MARK	DATE	DESCRIPTIONS	BY	CH'D
1	05/22/06	E2 CAP BEAM ISD, E2TI CCO 34	AS	NV

SAN FRANCISCO OAKLAND BAY BRIDGE
EAST SPAN SEISMIC SAFETY PROJECT
SELF-ANCHORED SUSPENSION BRIDGE
(SUPERSTRUCTURE & TOWER)

PIER E2 DETAILS NO.2

PIER E2 DETAILS NO. 3

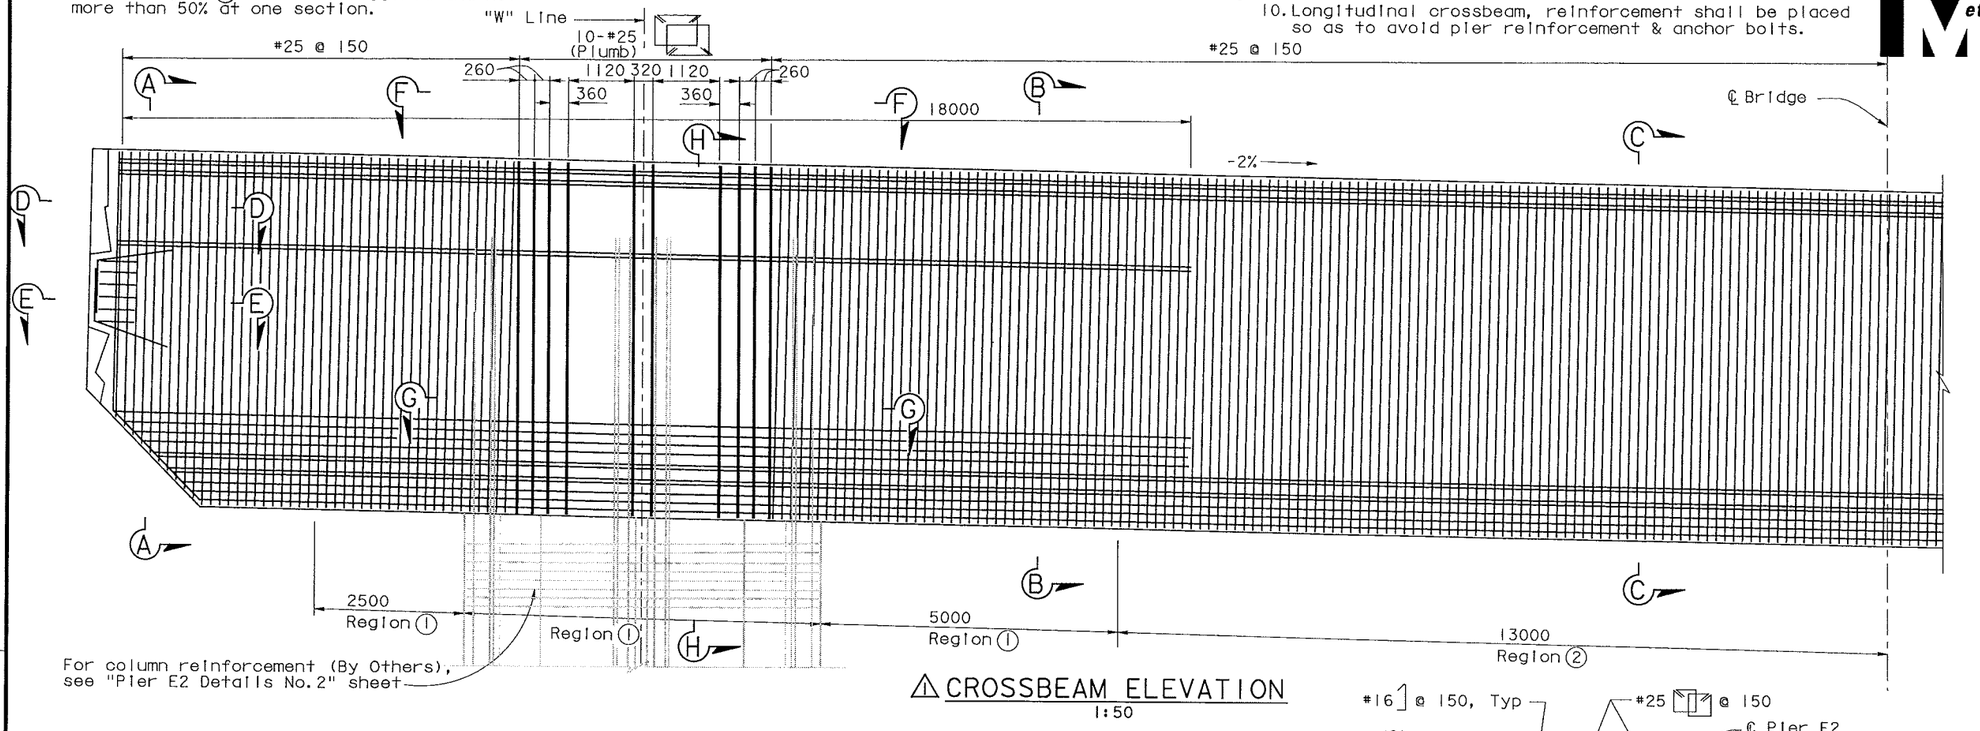
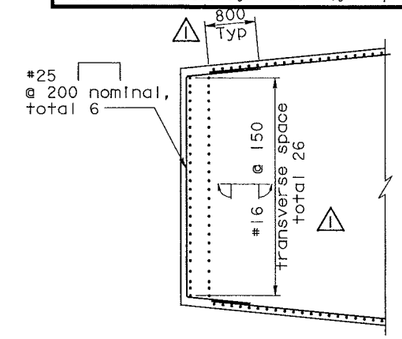
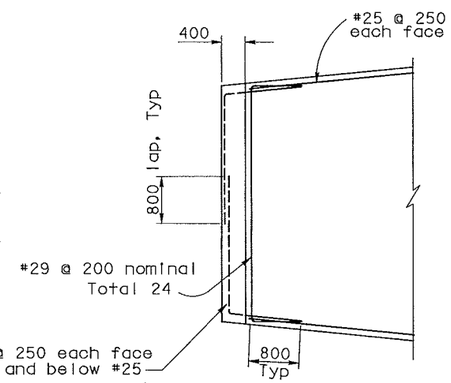
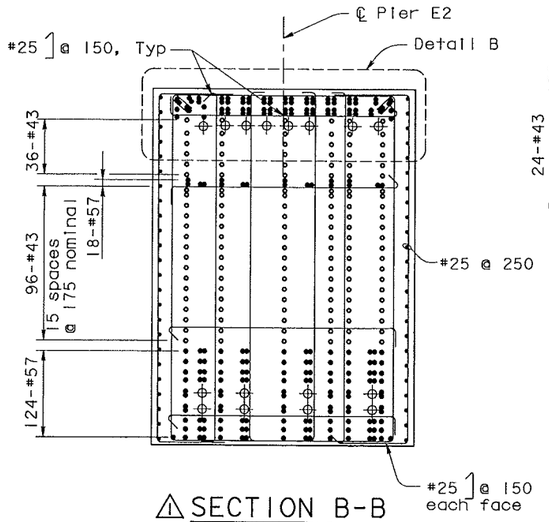
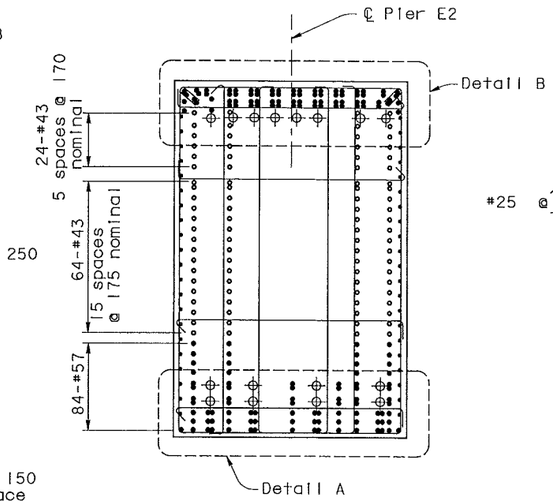
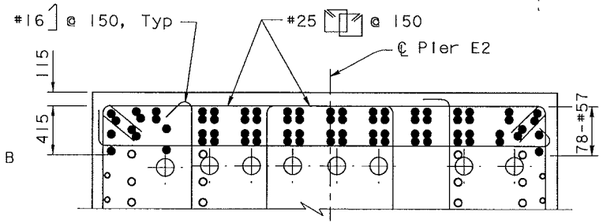
MARK	DATE	DESCRIPTIONS	BY	CH'D
1	05/22/06	E2 CAP BEAM ISD	AS	NV

PIER E2 DETAILS NO. 4

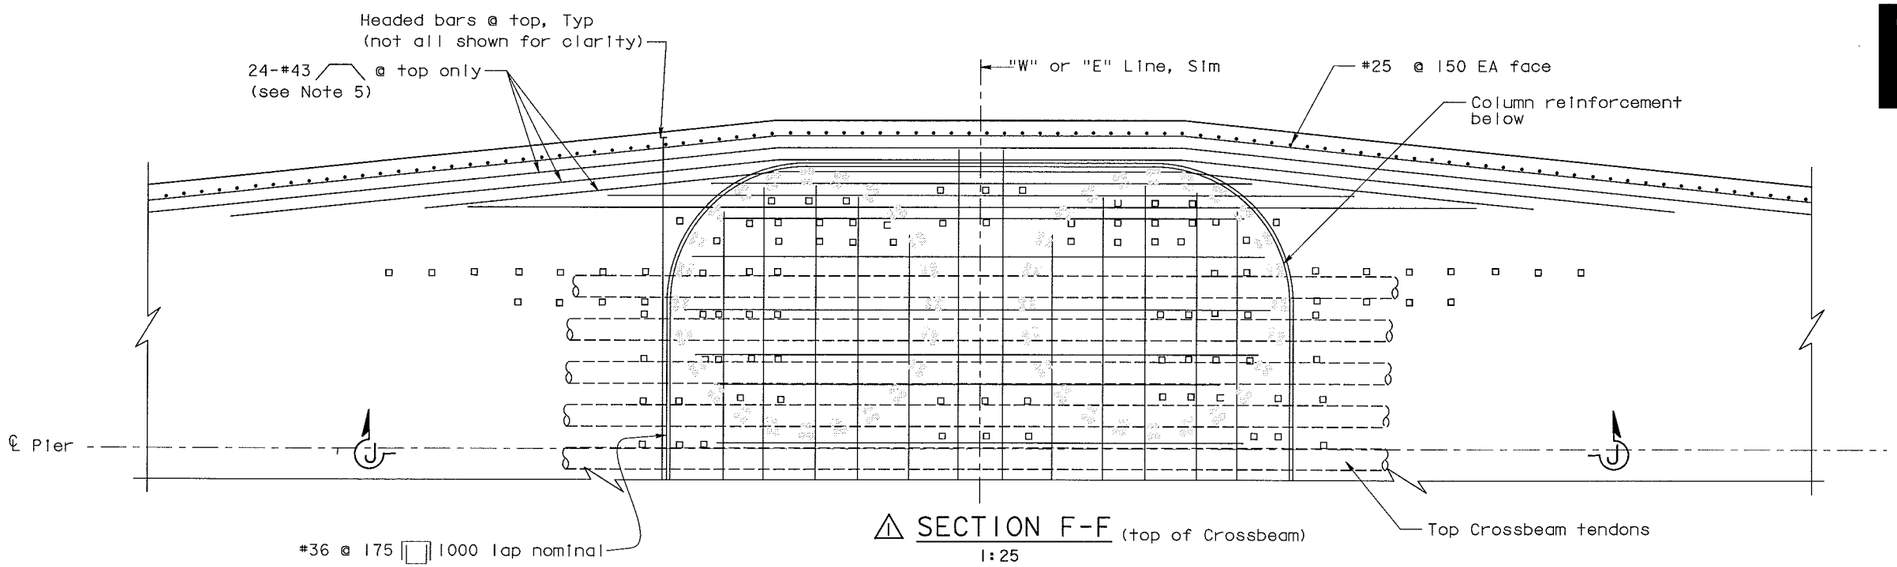
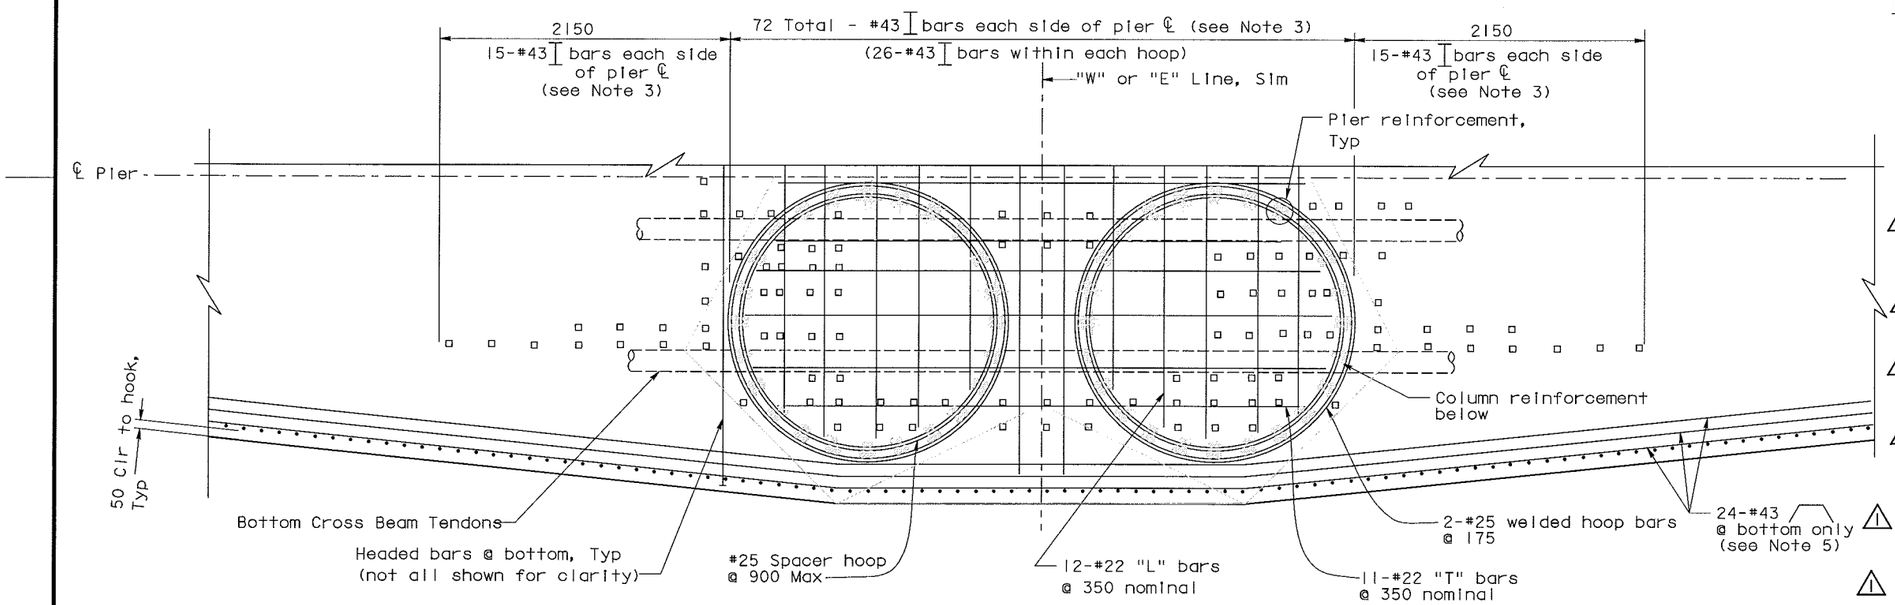
4. ⚠ Headed reinforcement may consist of rebar with either friction welded plates or threaded heads. Threaded heads must equal or exceed the capacity of welded plates.

5. ⚠ Cut off #43 top and bottom longitudinal bars at widened beam to avoid main Crossbeam longitudinal reinforcement as required.
6. ⚠ Reinforcement details reflect strict adherence to the location of pier column reinforcement defined on "Pier E2 details No. 2" sheet.

7. ⚠ Adequate fabrication and placement of all permanently embedded items may require more stringent tolerances than ordinary industry standards. It shall be the Contractor's responsibility to ensure the adequate fabrication and placement of all permanently embedded items within the geometric constraints of the plans.

8. ⚠ For anchor rod layouts and details for bearings and shear keys, see "Pier E2 details No. 9" sheet.
9. ⚠ For Section J-J see "Pier E2 Details No. 7" sheet.

PIER E2 DETAILS NO.5

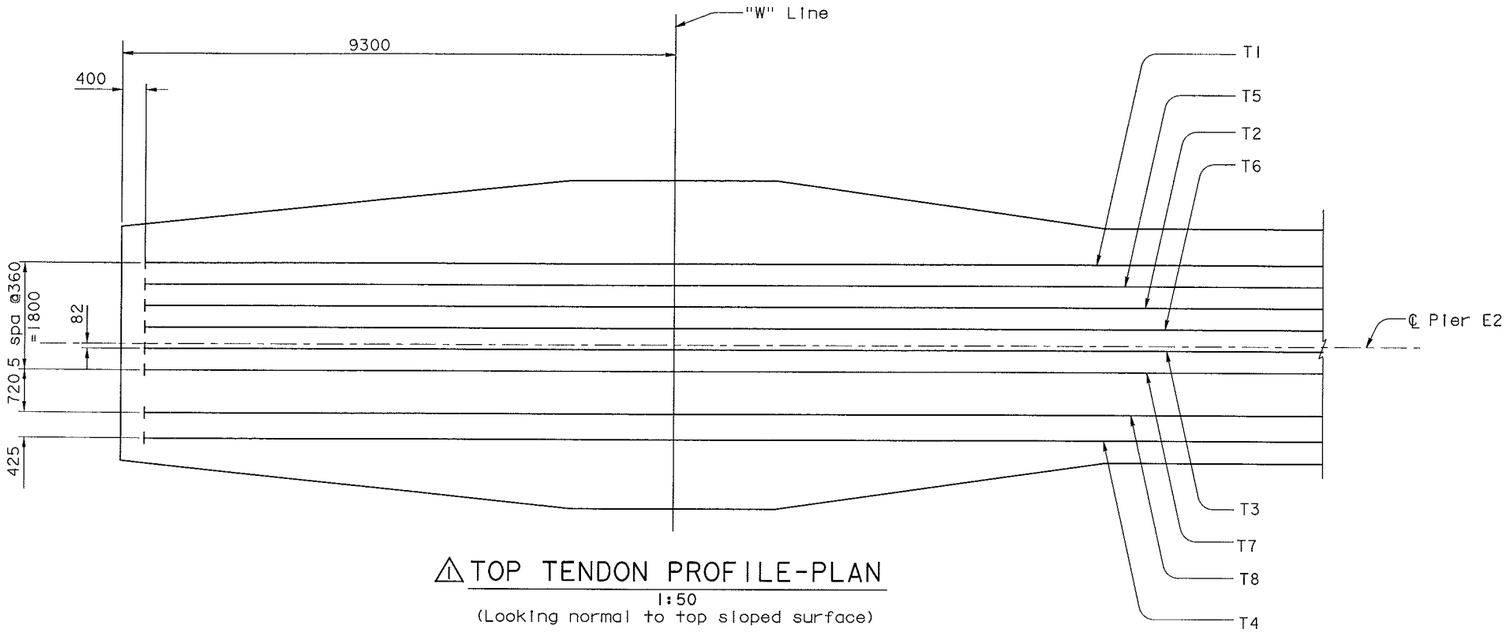
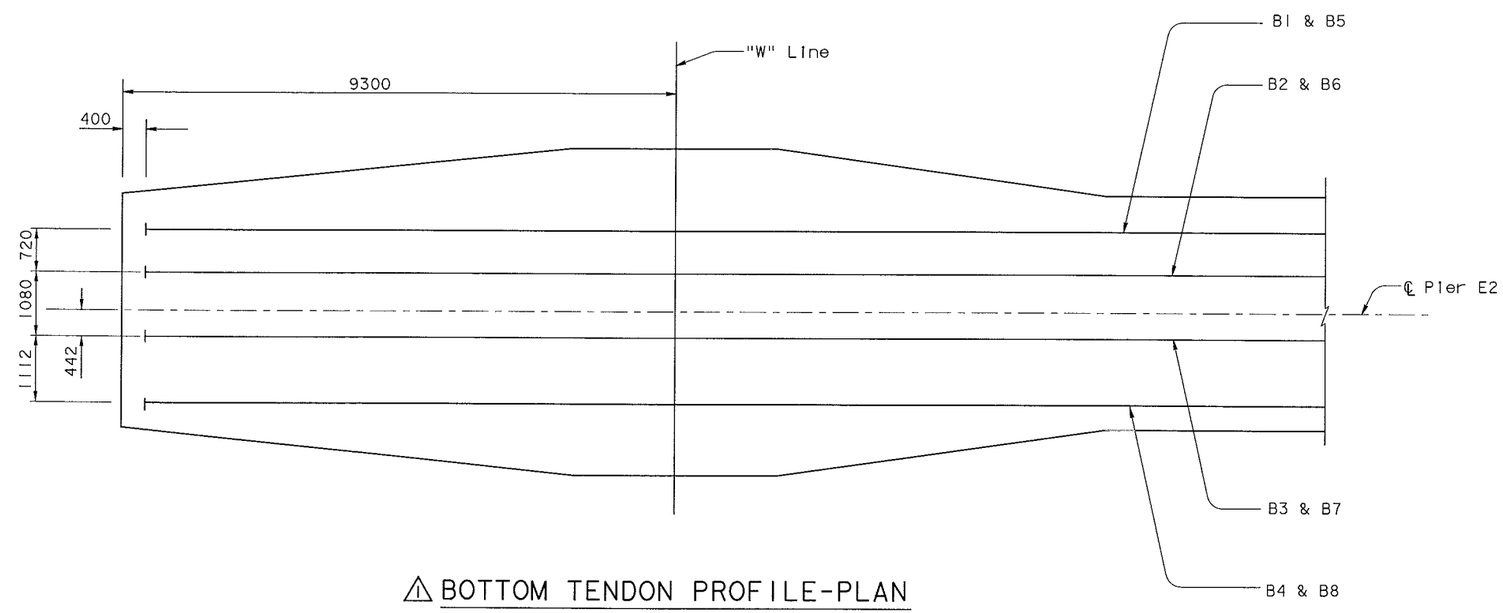
1. "W" Line shown, "E" Line similar.
2. For tendon anchorage block-out details, see "Pier E2 Details No.8" sheet.
3. For concrete crossbeam reinforcement, see "Pier E2 Details No.3", "Pier E2 Details No.4", and "Pier E2 Details No.7" sheets. ⚠1
4. For stressing force, use two end stressing and initial jacking stress $= 0.75\ f_{pu} = 0.75 \times 1860 = 1390$ MPa.
5. For additional prestressing notes, see Prestressing Notes" sheet.
6. The post-tensioning and grouting sequence shall prevent ducts from crushing.
7. ⚠1 The outer diameter of the PT duct shall not be greater than 180 mm.

PIER E2 DETAILS NO. 7

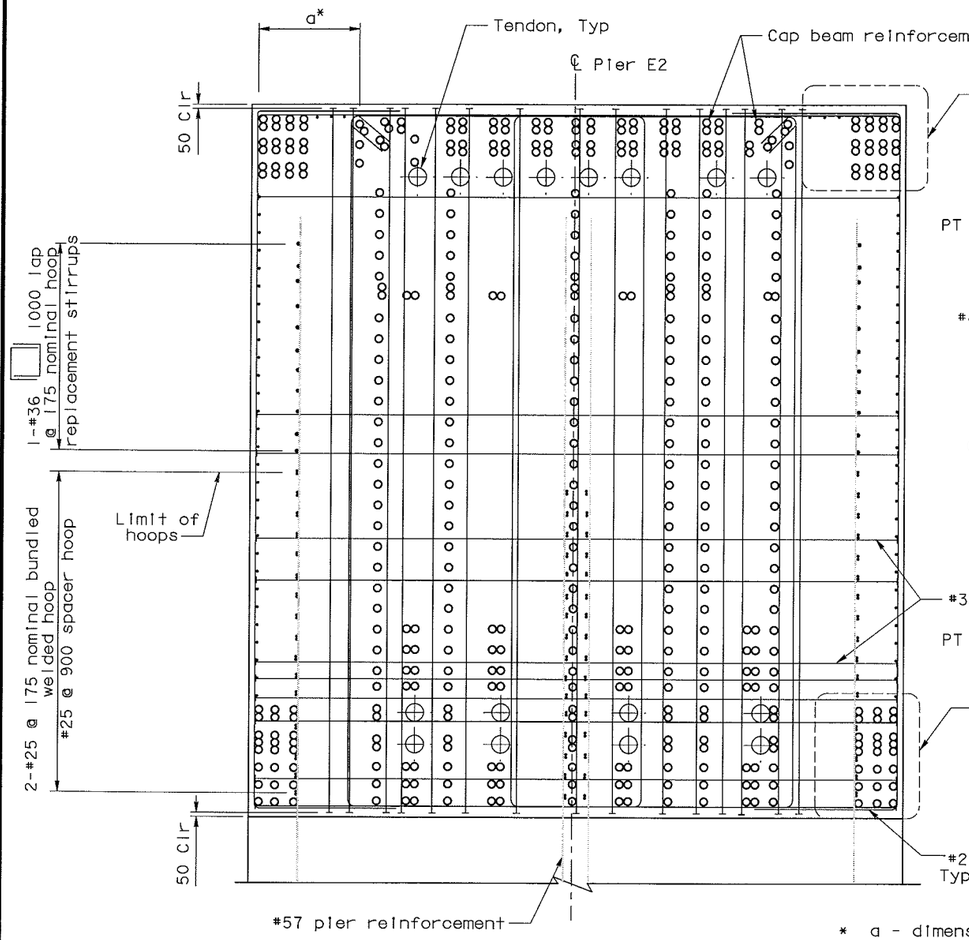
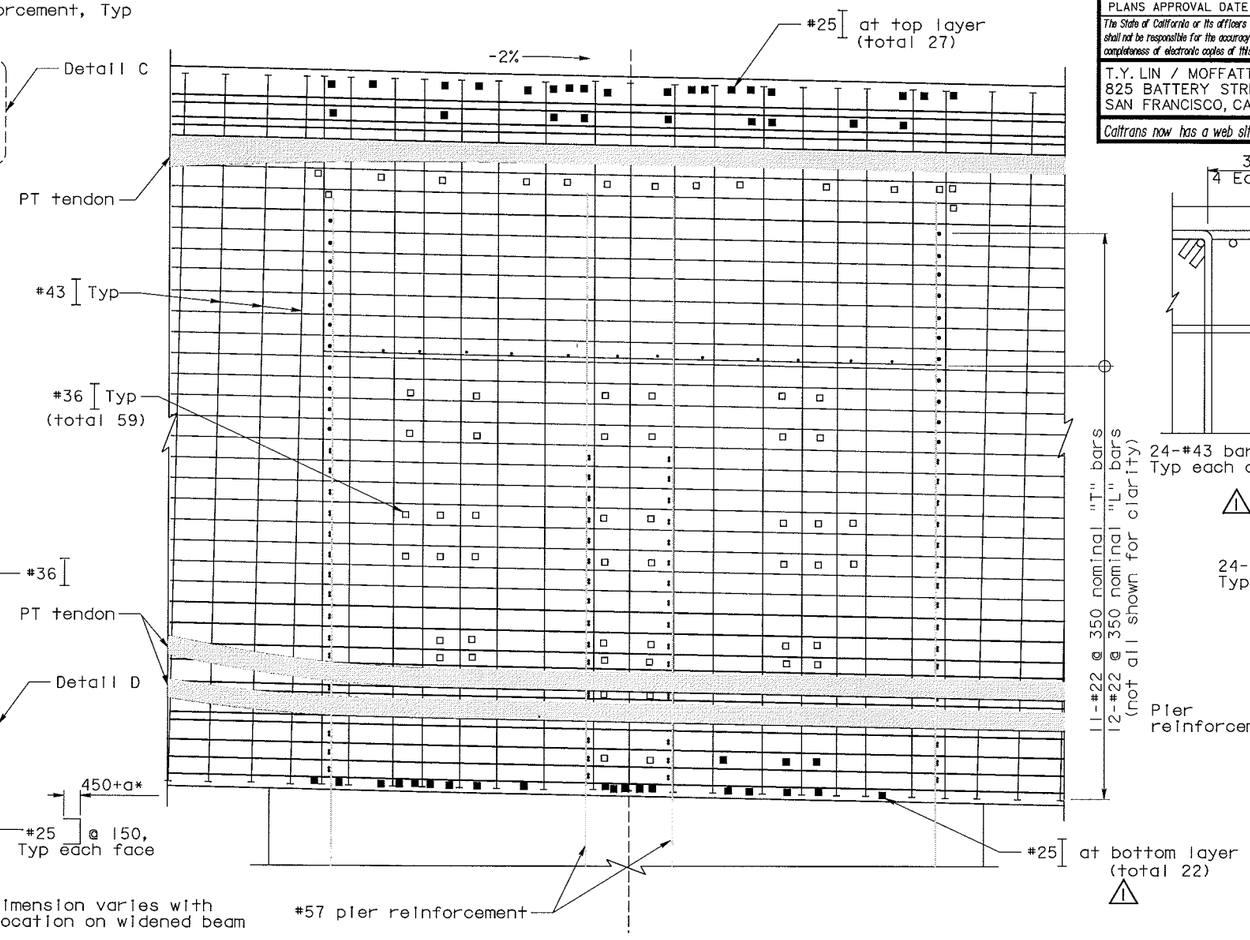
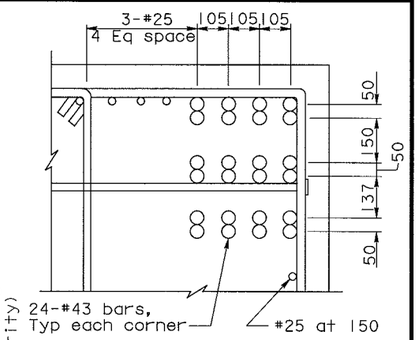
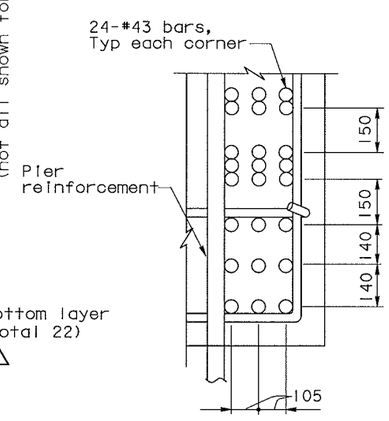
⚠ 1. Adjust reinforcement as required to clear column reinforcement. Bars can be moved and bundled to adjacent bars that clear column reinforcement.

⚠ 2. For additional notes, see "Pier E2 Details No.3" and "Pier E2 Details No.4".

PIER E2 DETAILS NO. 10

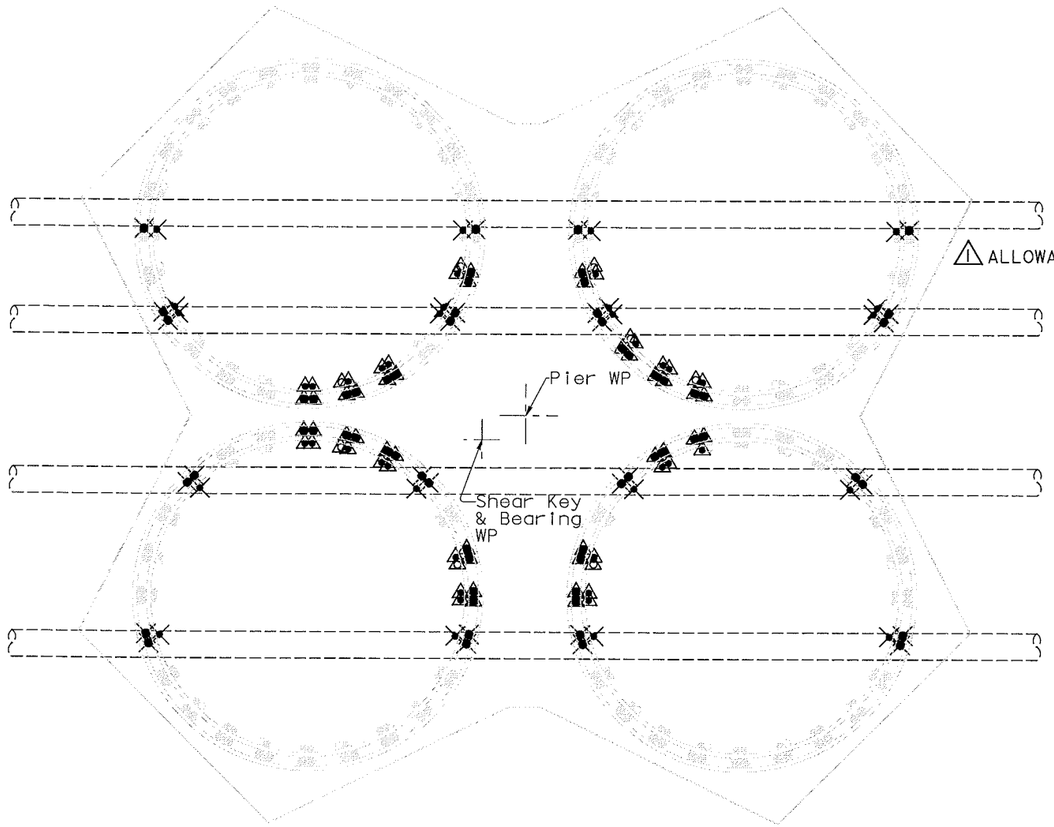
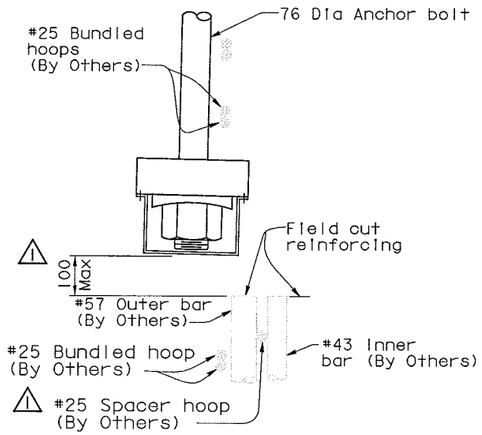
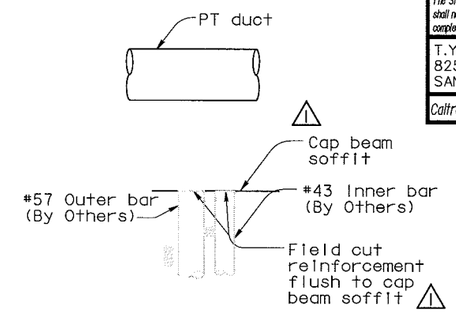
⚠ (Allowance shown is theoretical and is for information only. Not for construction). (see Note 2 thru 5)

- o Anchor bolts length = L1
- • Anchor bolts length = L2
- ⚠ × Indicates #43 or #57 column reinforcement may be field cut below the ducts. See "Allowance for PT duct".
- ⚠ △ Indicates #43 or #57 column reinforcement may be field cut below the anchor bolt or anchor PL. See "Allowance for anchor bolt and anchor plate".

1. Local confining spiral reinforcement for bearing HS bolts shall be provided by hardware suppliers; not shown for clarity.
2. ⚠ Column reinforcement to be field surveyed.
3. ⚠ Rotate anchor plates as necessary to clear column reinforcement.
4. ⚠ Contractor may field cut existing column reinforcement marked with X or △ to clear PT ducts and shear key anchor bolt/anchor plate. See Field Cut Detail.
5. ⚠ Prior to cutting any column reinforcement, the Contractor is required to submit locations and number of bars to be field cut for Engineer's review and approval.
